Addendum / Addenda

No./N^o
1

Project Description / Description de projet NRC Uplands - Building U89B Utility Supply Upgrade		
Solicitation No./ No de sollicitation 16-22027	Project No./N ^o de projet 4056	W.O. No./N ^o d'ordre de travail A1-005791
Departmental Representative / représentant ministériel Mark O'Connor		Date June 10, 2016
<p>Notice: This addendum shall form part of the tender documents and all conditions shall apply and be read in conjunction with the original plans and specifications.</p>		<p>Nota: Cet addenda fait partie intégrale des dossiers d'appel d'offres; toutes les conditions énoncées doivent être lues et appliquées en conjonction avec les plans et les devis originaux.</p>

drawing: **ELECTRICAL DETAILS #1**

A HYDRO OTTAWA POLE - FOR REFERENCE ONLY
 E06 N.T.S.

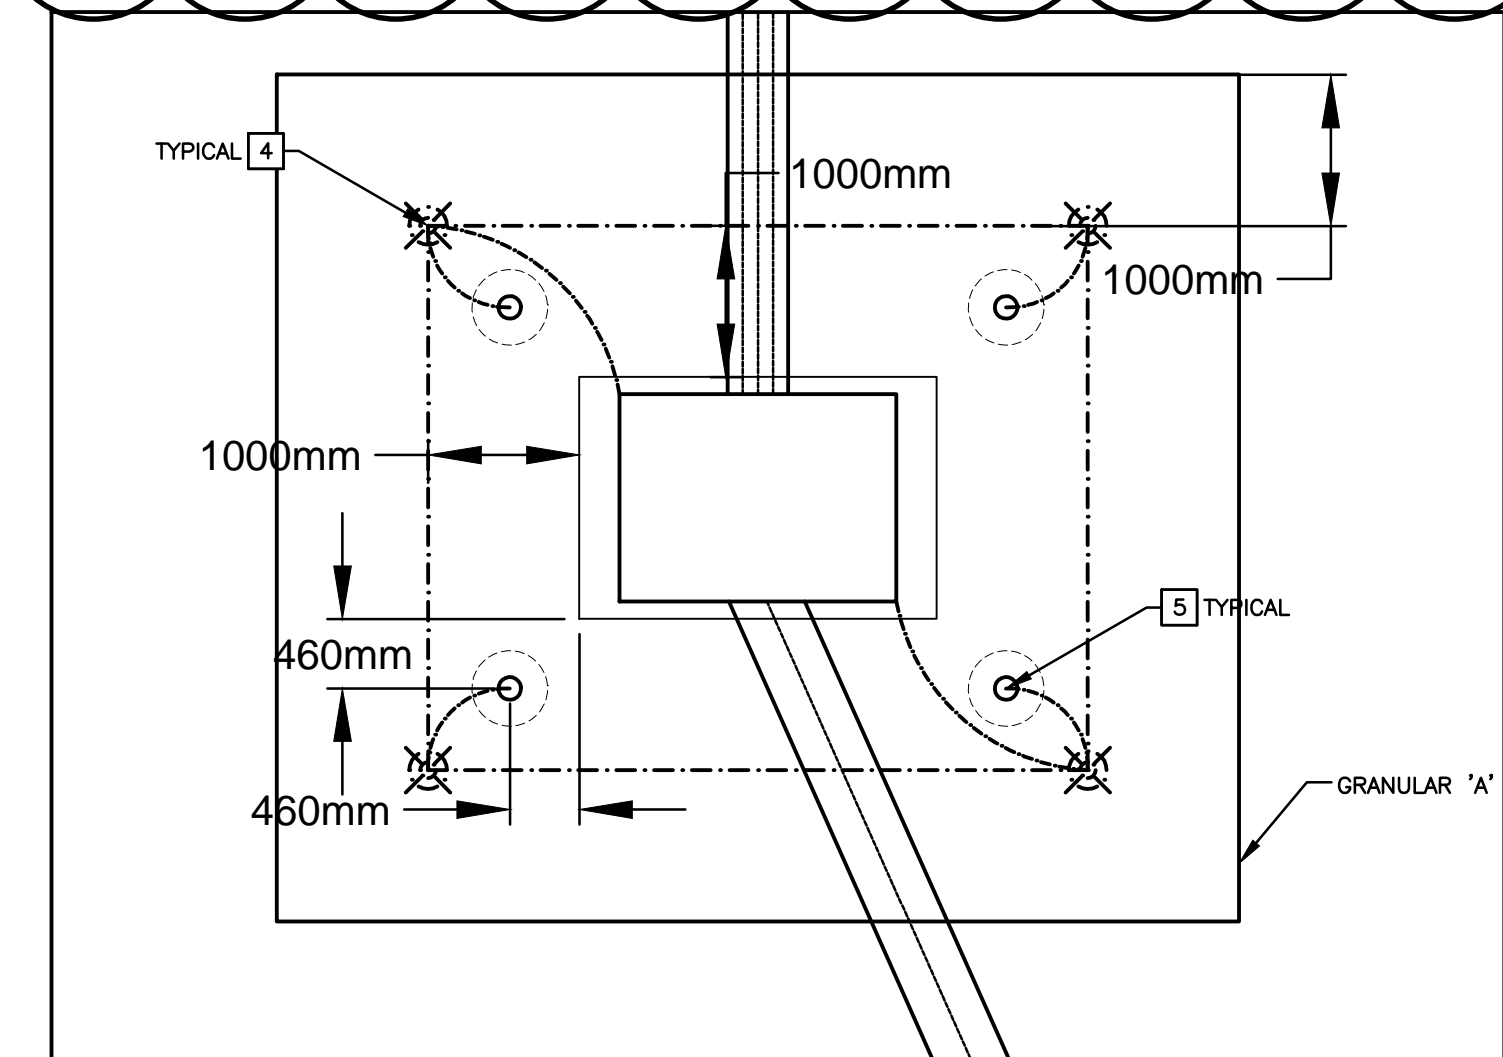
1. Refer to drawing 4056 – E06. Detail A, Hydro Ottawa Pole and associated notes have been update. Detail is for reference only. The pole updates include:

- a. Changing from a horizontal load break to fused cutouts.
 - b. Grounding conductors from medium voltage load break to ground grid no longer required.

- c. Gradient control mat at the pole no longer required.
 - d. Crushed stone at the base of the pole is no longer required.
2. Clarification/Response to questions.
